**COMMISSION OF ARCHITECTURAL REVIEW
STAFF REPORT
May 23, 2017, Meeting**

12. **COA-016788-2017** (D. Kleyman)

**2310-2310 ½ Venable Street
Union Hill Old and Historic District**

Construct a new duplex.

1905 Sanborn Map for the Subject Block

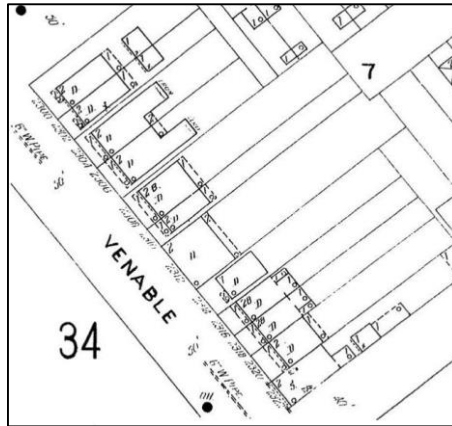
The applicant is proposing to align the structure with the property to the west. This setback is consistent with the setback pattern prevalent in the district.

The setback of the building to the west is consistent with the historical pattern for the block. The proposed structure matches this setback.
